ENGINE - FUEL AND CONTROL - TO PROVIDE A NEW ELECTRONIC ENGINE CONTROL (EEC) WITH THE
A5 SCN11 SOFTWARE CONFIGURATION - CATEGORY CODE 4 - MOD.ENG-73-0086

V2500-ENG-73-0086

**SERVICE BULLETIN**

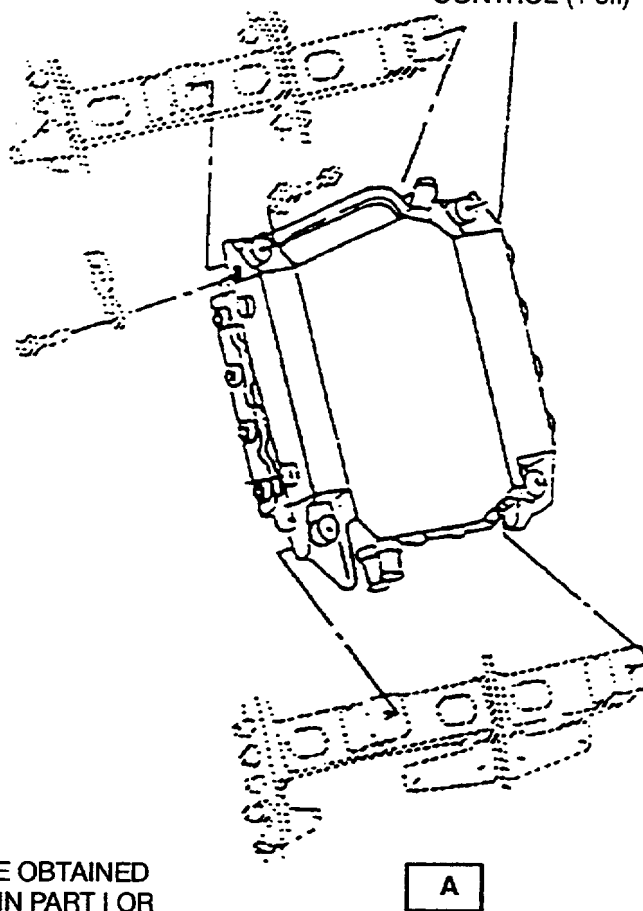
- (1) Remove the 808050-4-026 (2A3223) Electronic Engine Control by the approved procedure given in Reference (6), Chapter/Section 73-22-34, Removal/Installation. Refer to Figure 1.

- (1) Do a modification of the 808050-4-026 (2A3223) Electronic Engine Control (See Reference (7), Chapter/Section 73-22-34, Fig/Item No.01-280) and reidentify by the procedures given in Reference (2).

INSTALL THE 808050-4-028
(2A3250) ELECTRONIC ENGINE
CONTROL (1 off)*

*THE NEW CONTROL CAN BE OBTAINED
BY DOING THE PROCEDURE IN PART I OR
PART II OF THIS SERVICE BULLETIN
